## Change in performance requirements for laden vehicles:

### For M1 Category vehicles

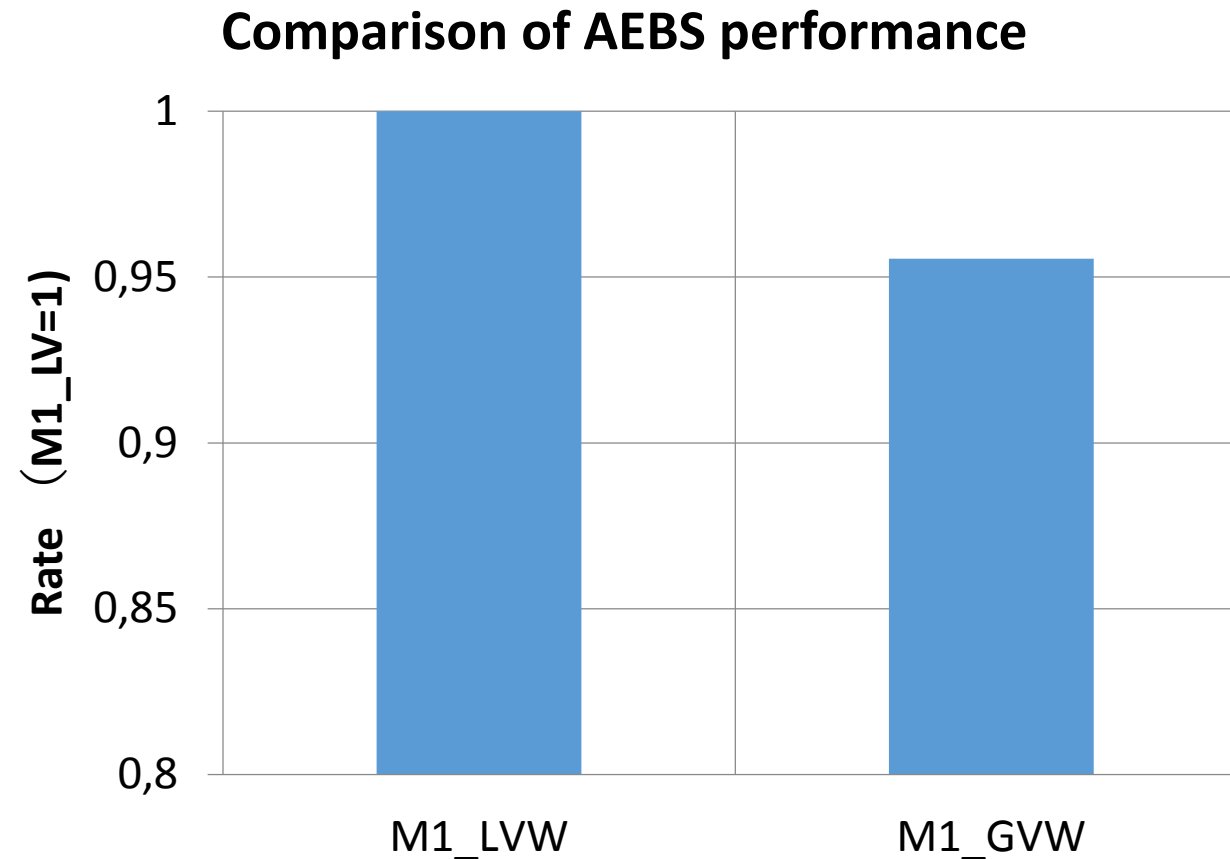
Reason for performance difference between LVW and GVW

- LVW has better deceleration performance than GVW.

### Alignment Methods

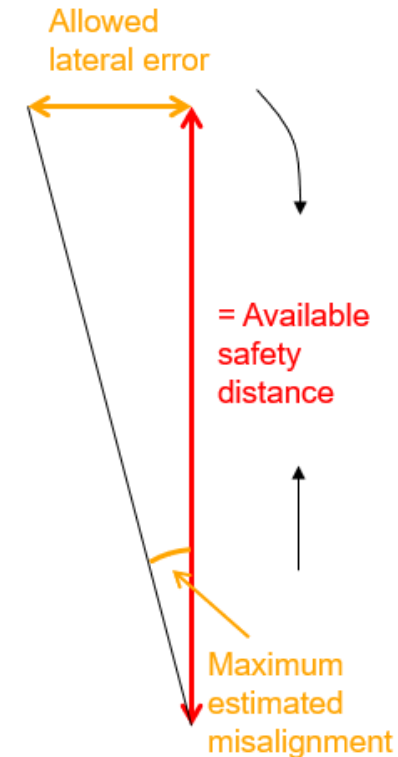
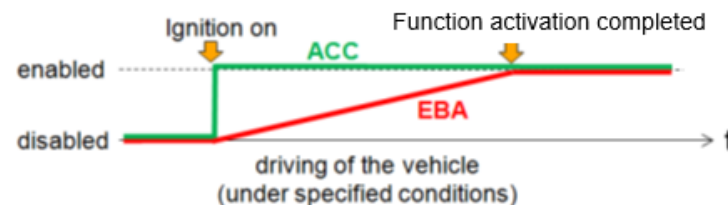
#### Misalignment Monitoring – function activation (safety distance)

- Safety relevant functions limited to objects detected within the longitudinal „safety distance“
- safety distance is defined as that distance where the maximal expected lateral error exceeds a defined limit
- at start the safety distance is 0m
- Safety distance increases, depending on the maximal expected misalignment

## Average Braking Demand

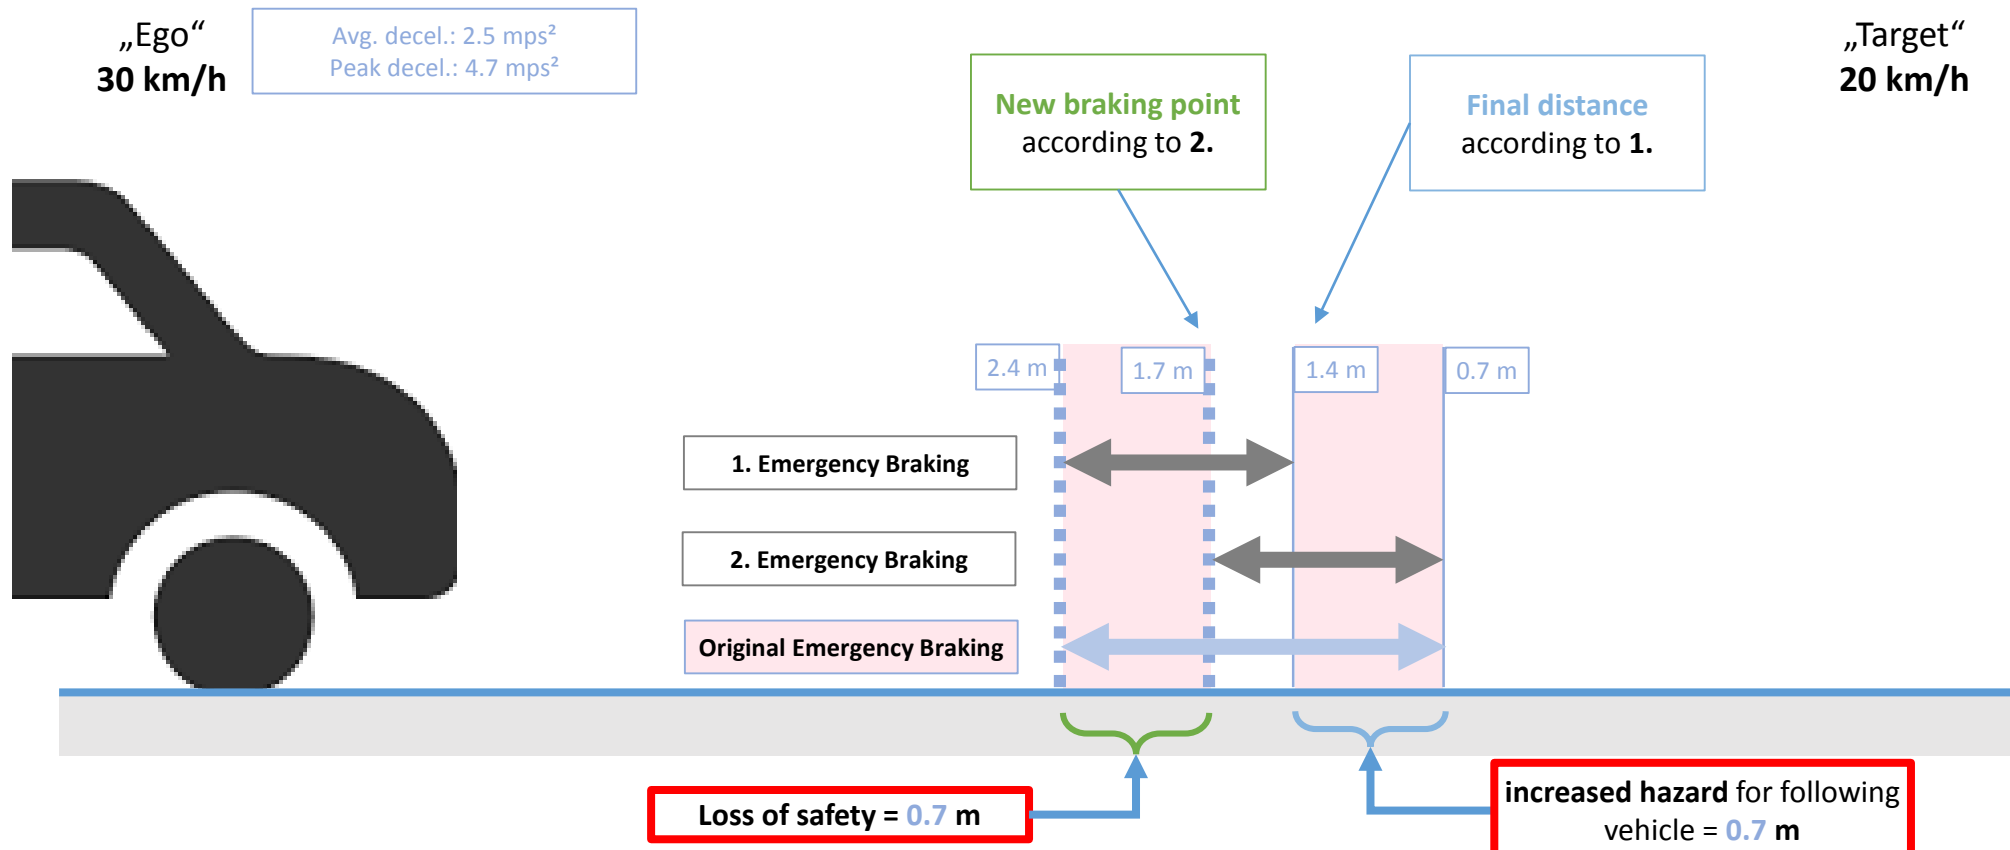
CCRm-Scenarios: today in the market, not convenient

Impact of demanded average deceleration ( $-3.8 \text{ m/s}^2$ ) on emergency braking in lower speed range.

1. Keeping today's begin of emergency braking phase
2. Passing today's emergency braking point in order to keep today's final distance to target

## Average Braking Demand

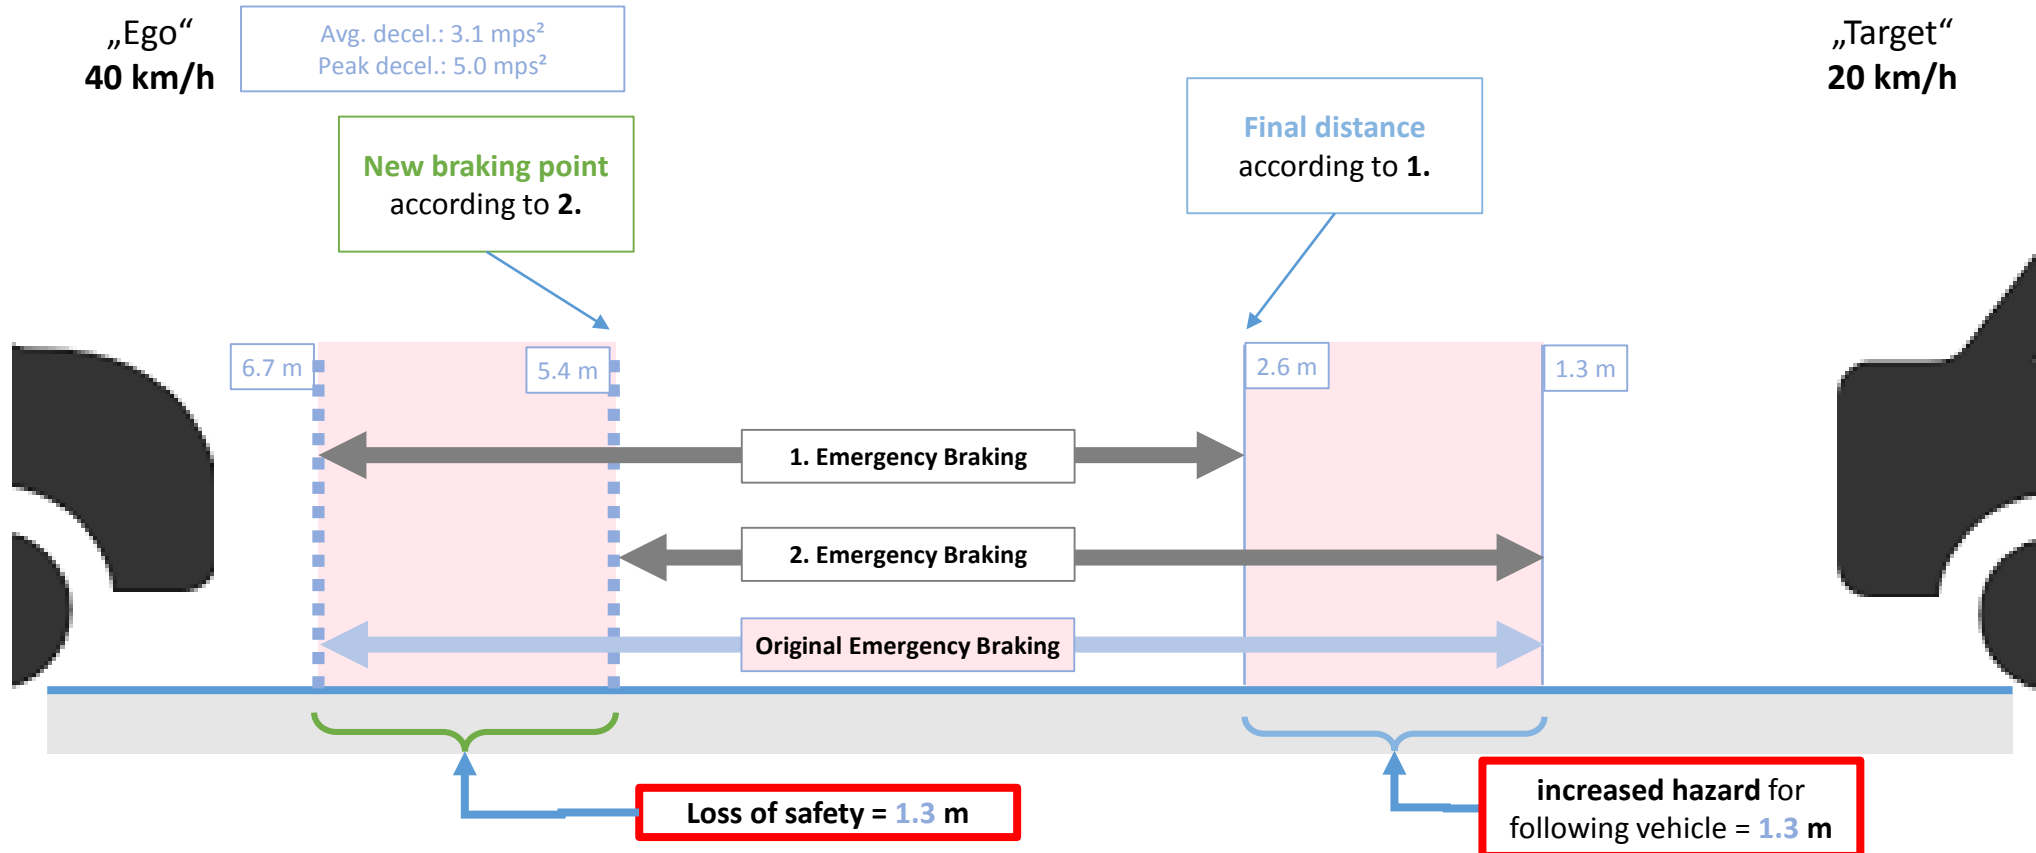
CCRm-Scenarios: today in the market, not convenient

Impact of demanded average deceleration ( $-3.8 \text{ m/s}^2$ ) on emergency braking in lower speed range.

1. Keeping today's begin of **emergency braking phase**
2. Passing today's emergency braking point in order to **keep** today's **final distance** to target
